TOWN PLANNING BOARD
DEAR SIR/MADAM,

Temporary Warehouse (excluding Dangerous Goods Godown) and Open Storage of Miscellaneous Goods with Ancillary Facilities and Associated Filling of Land for a Period of 3 Years At Lots 175RP (Part) & 173(Part) In DD87 TKL , N.T.

圖號: 7

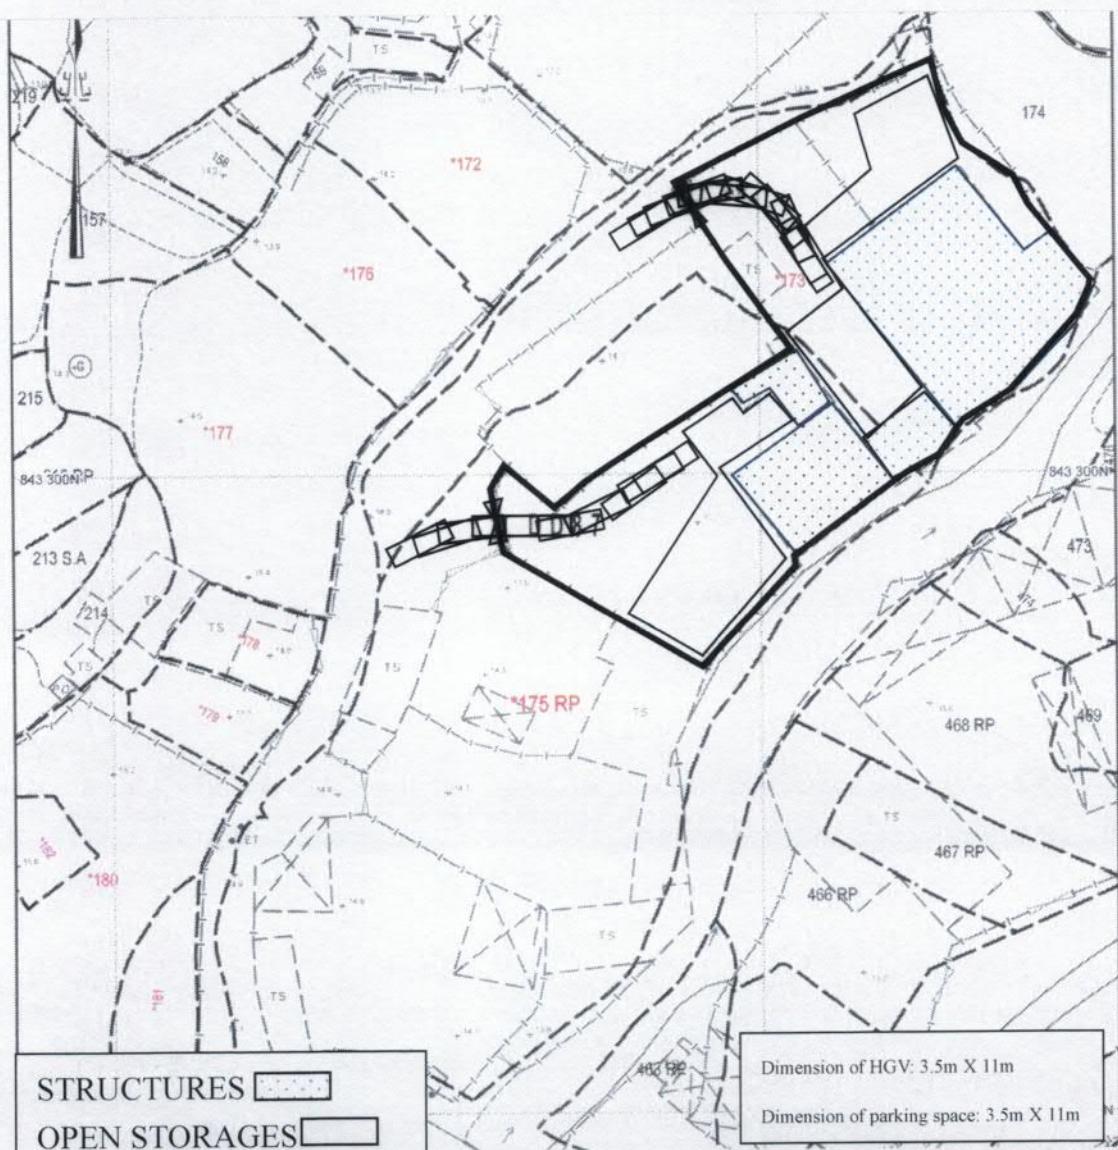
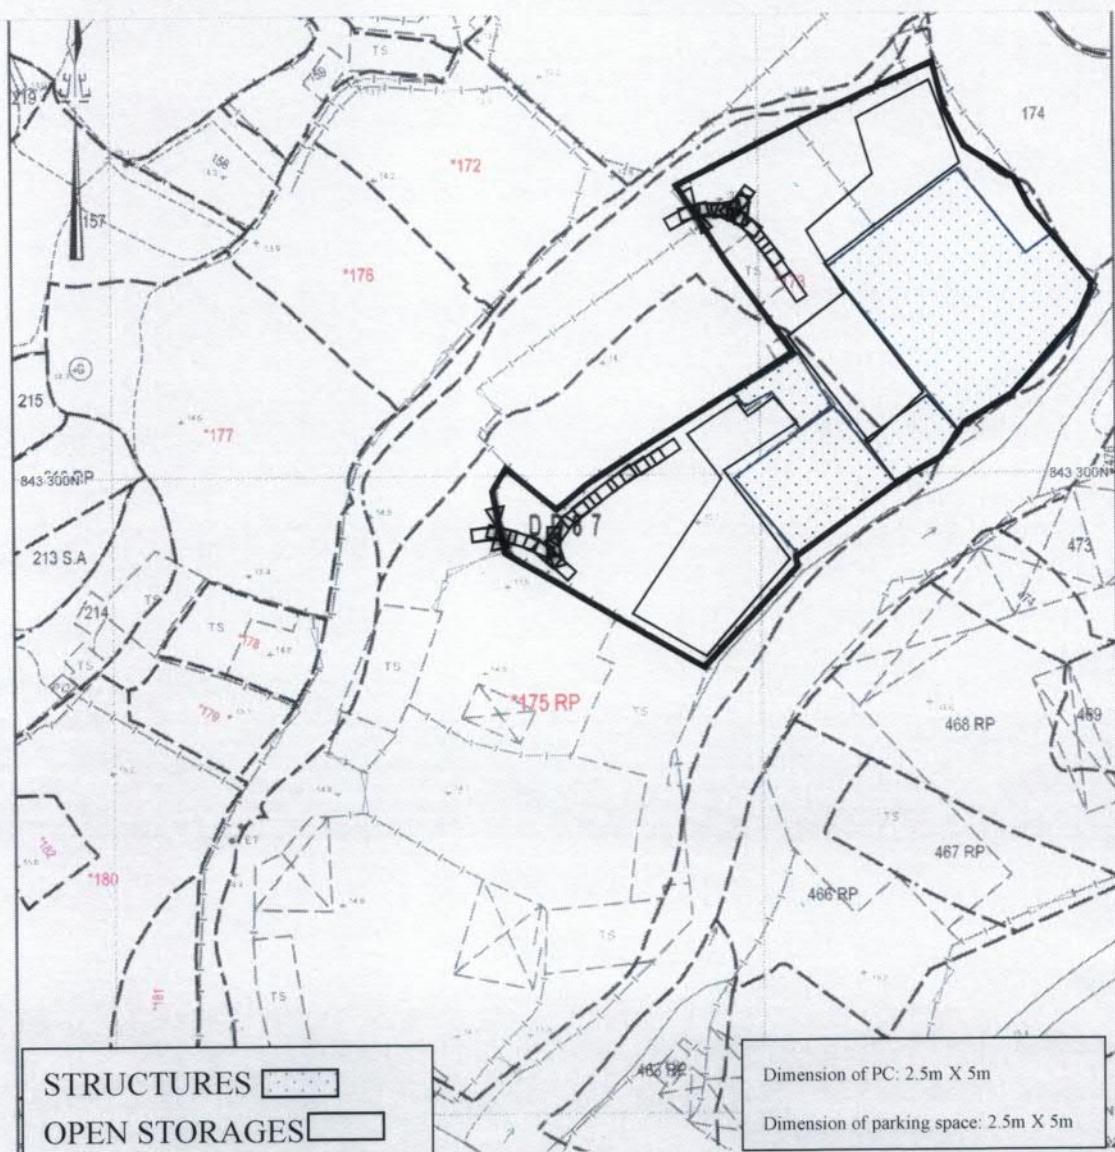
Comments from the Commissioner for Transport	
(i) The swept path of heavy goods vehicle encroaches on the open storage area. The applicant should update the swept path analysis shown in the layout plan with all buildings/storage areas/facilities/car parking spaces for clarity. The swept path analysis of private car is also required.	Attached please find the updated swept path analysis diagram 7 , 8 (heavy vehicle) 9 , 10 (private car)
(ii) The applicant shall advise the provision of pedestrian facilities and management measures to ensure pedestrian safety.	The applicant will be erected “STOP AND GIVE WAY” and “BEWARE OF PEDESTRIANS” signs at the ingress/egress to ensure pedestrian safety.
(iii) The applicant shall advise the management/control measures to be implemented to ensure no queuing of vehicles outside the subject site.	Staff will be employed at site to direct all vehicles In & Out. As there are two trips maximum per day, and all vehicles are registered in advance for smooth maneuvering within the application site.
